Project Name	: Horton Heath, Eastleigh
Job No	: 19-367
Note Title	: Flood Risk Assessment and Drainage Strategy - Addendum 1
Author	: JW
Checked	: JH
Approved	: GG
Date	: May 2021

1.1.4 Following the submission of the application, comments were received from Hampshire County Council (HCC) in their capacity as the Lead Local Flood Authority (LLFA), in February 2021 (HCC reference: SWM/2021/0019). A copy of the LLFA consultation comments is provided in **Appendix A**.

Enquiries to	Sarah Reghif	*My reference*	SWM/2021/0019
Direct Line	0370 779 7497	*Your reference*	F/20/89500
Date	5 February 2021	*Email*	SWM.consultee@hants.gov.uk

Water Management Strategy

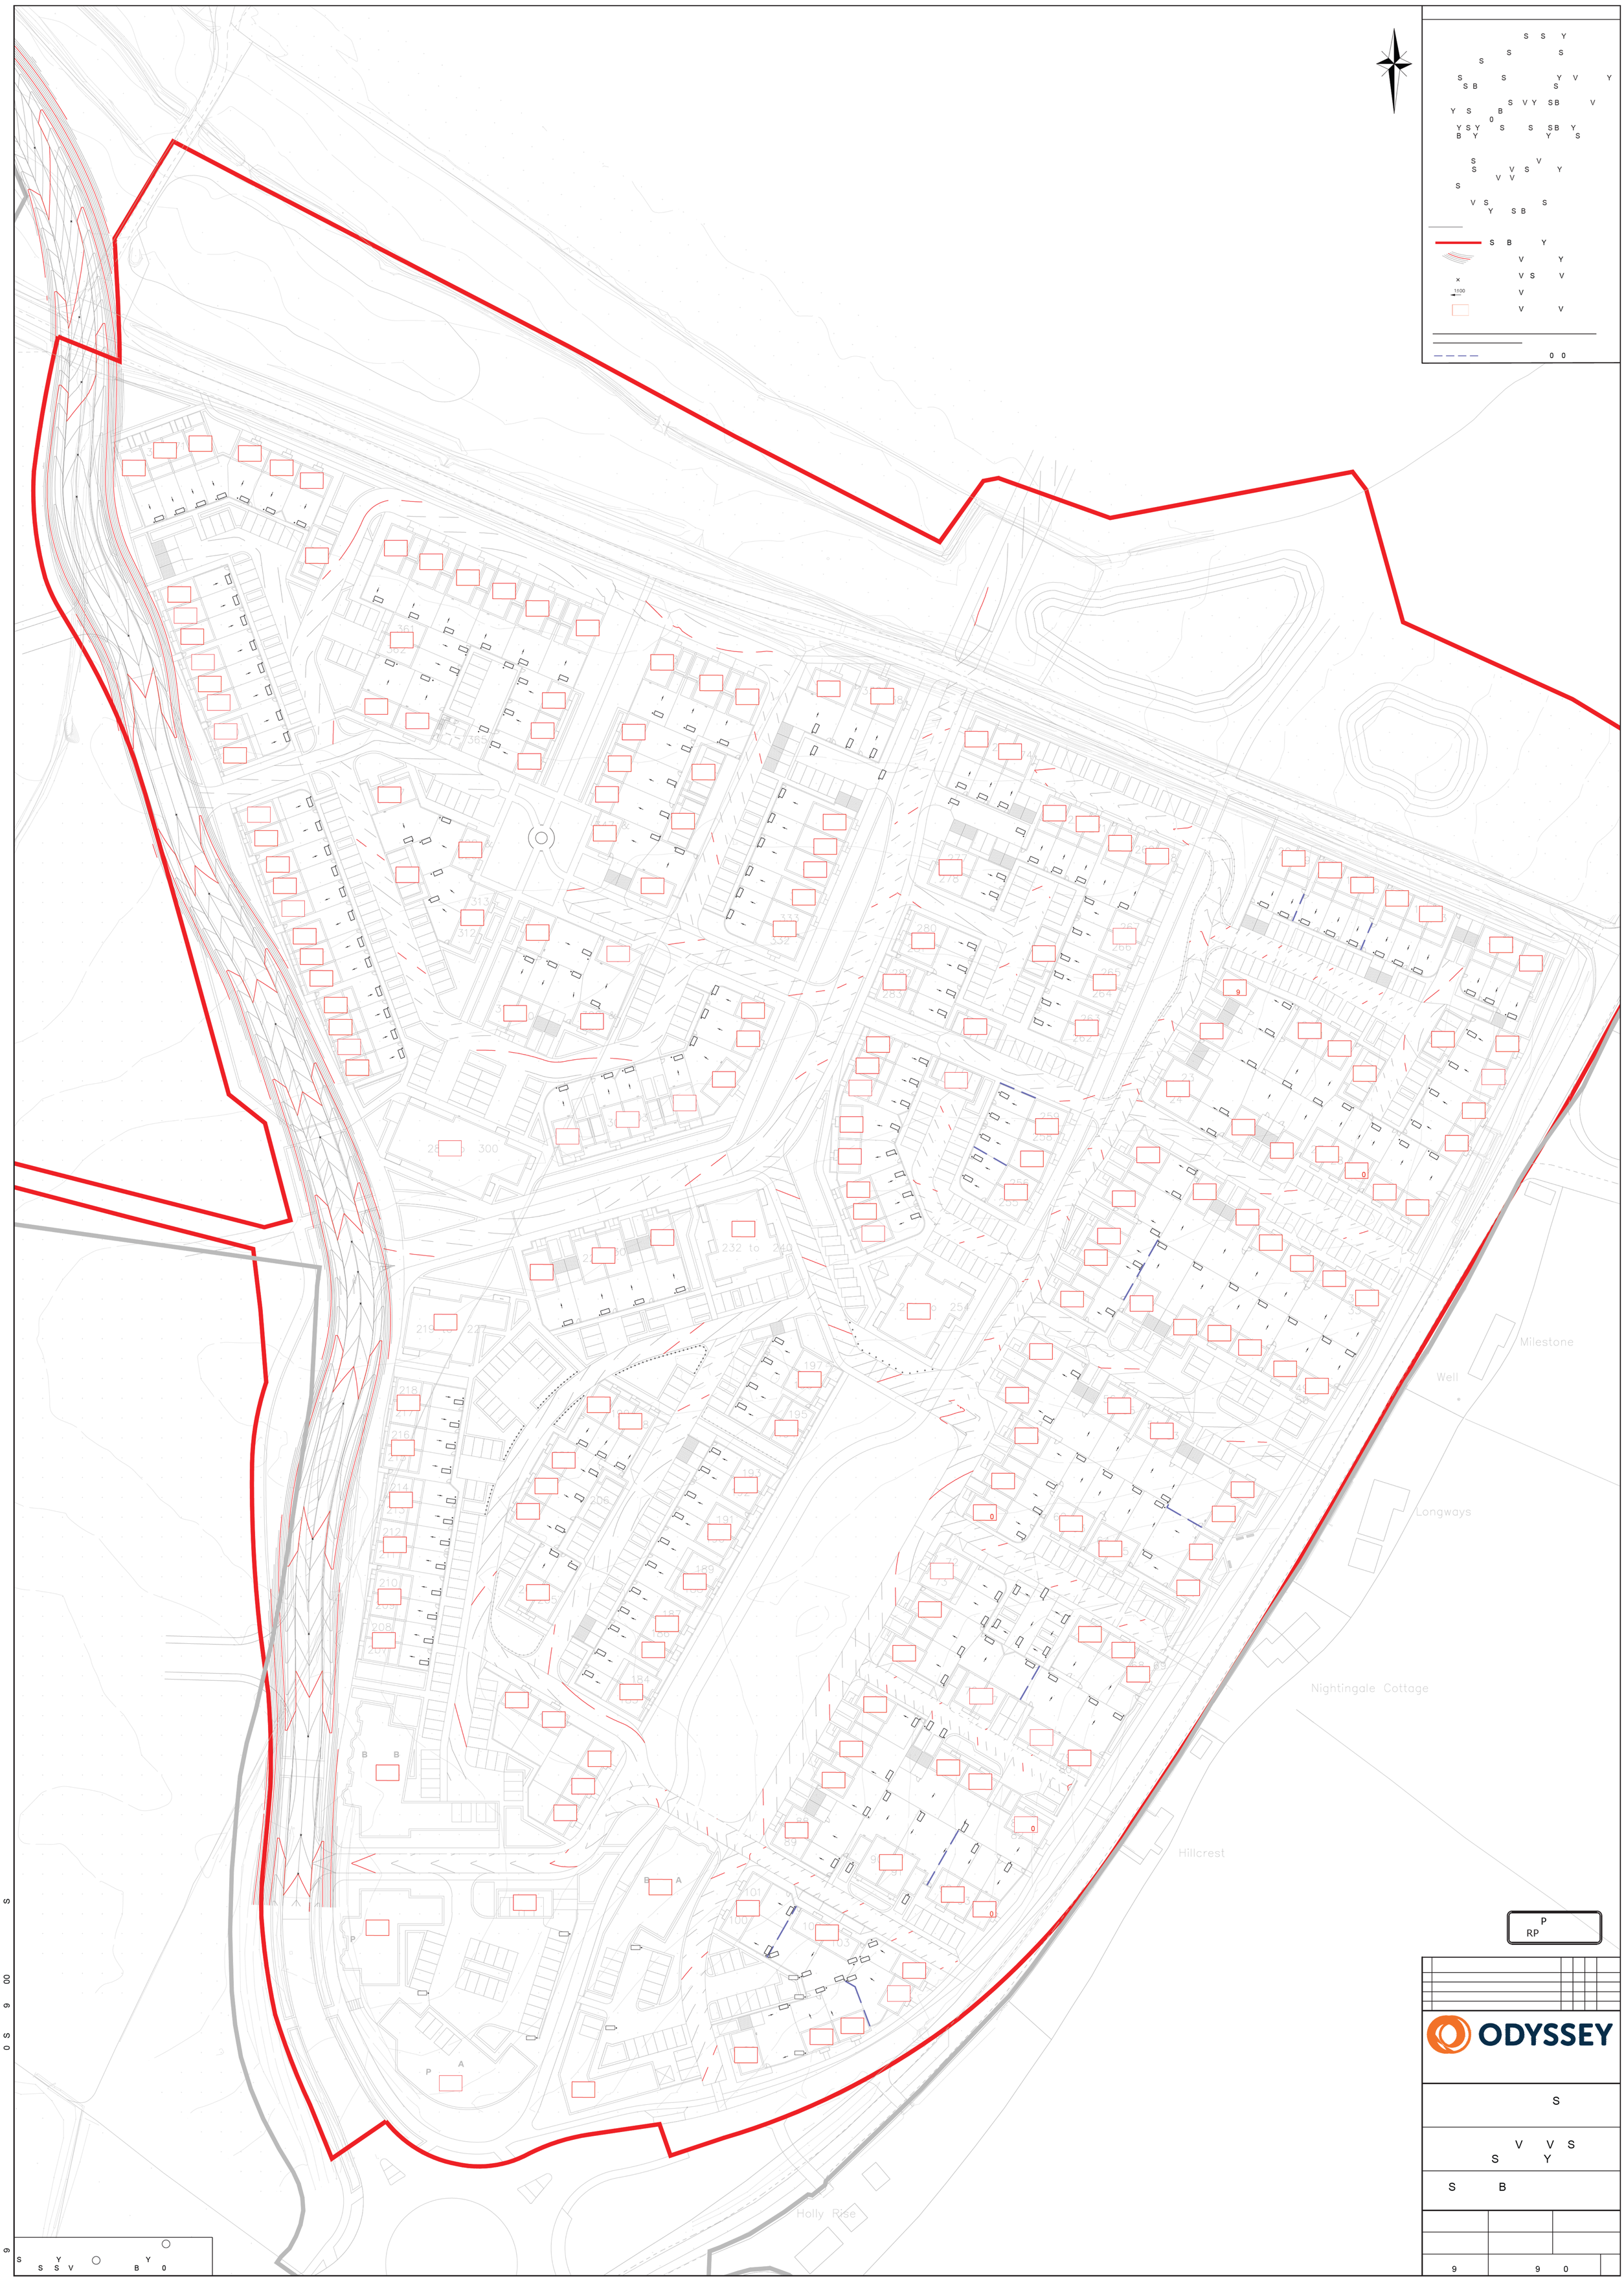
"*A series of what we believe to be swales are identified adjacent to the watercourse and in various locations around the development. These do not appear to be connected and there is a section that appears to go through basin I. There are also sections that appear to clash with the proposed access roads between the dwellings and the ponds. Please clarify these elements particularly as there appears to be an existing ditch in this location which would require ordinary watercourse consent if any alterations are proposed*."

A series of what we believe to be swales are identified adjacent to the watercourse and in various locations around the development. These do not appear to be connected and there is a section that appears to go through basin I. There are also sections that appear to clash with the proposed access roads between the dwellings and the ponds. Please clarify these elements particularly as there appears to be an existing ditch in this location which would require ordinary watercourse consent if any alterations are proposed.

2.1.9 The proposed swales are shown in blue on the drainage strategy. The basin and access roads are shown over existing hedges, which would be removed. The updated drawing is presented in **Appendix C**.

2.1.10 The proposed swales to the south-west of the site would drain into the main drainage system. The two enhanced swales on the north side of the site would be incorporated into the pipework; directing water through the enhanced swales would provide additional treatment. The outfall into Basin K has also been moved to better accommodate the swales. The storage volume that would be provided by the proposed swales has not been included in the hydraulic model as a conservative approach.
